REMARKS

FIG.4

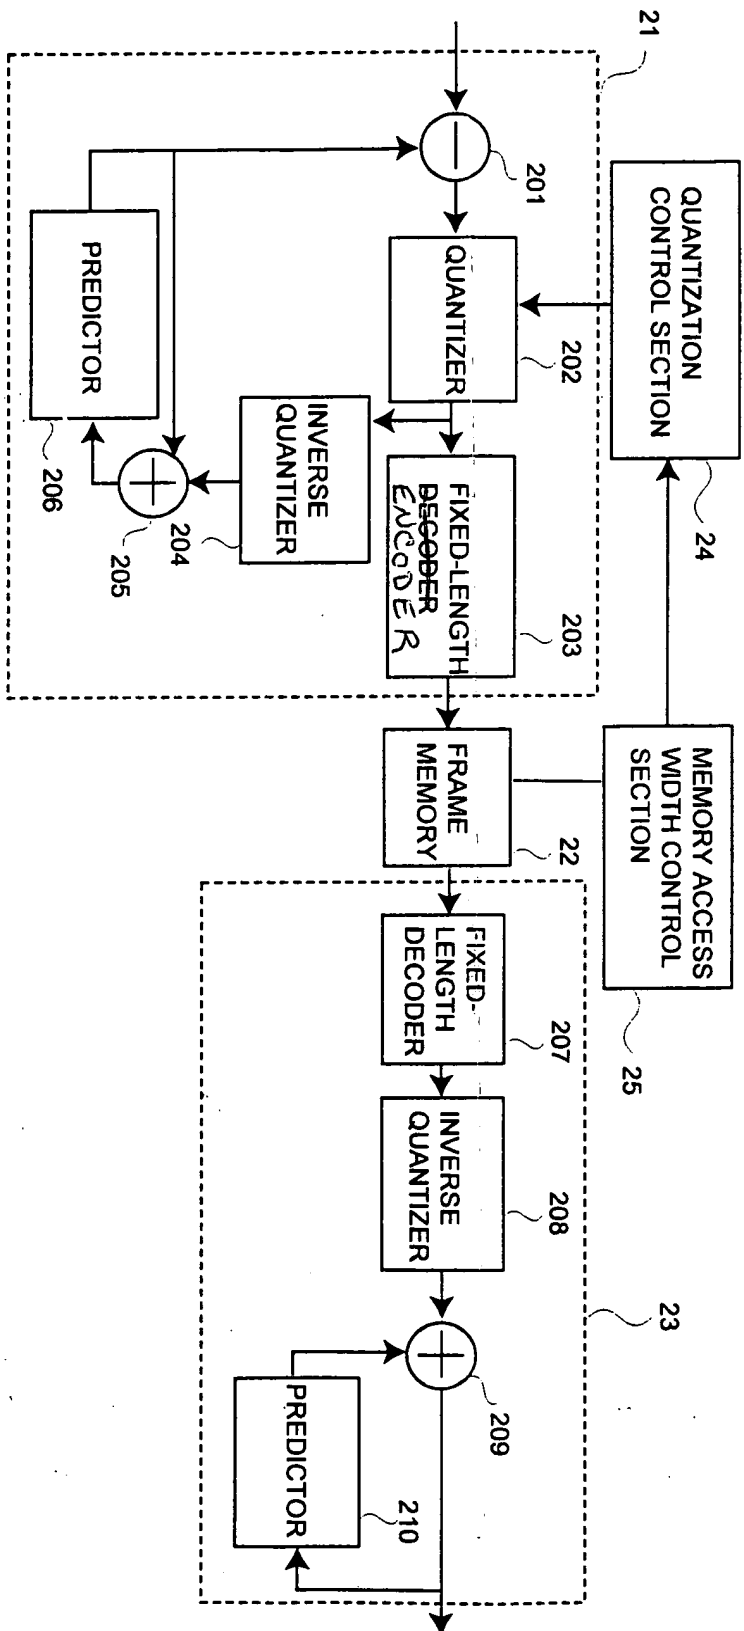
Fig. 4 has been amended to change Fixed-Length Decoder 203 to Fixed-Length Encoder 203 in accordance with the Examiner's suggestion in item 2 of the Office Action. It is also proposed to amend the figure by adding a line directly connecting the Memory Access Width Control Section 25 and the Frame Memory 22, generally corresponding to the line connecting the Frame Memory 106 with Access Width Control Section 110 in Figures 1 and 5. Approval of the drawing change is therefore respectfully requested.

Approved
6/18/02
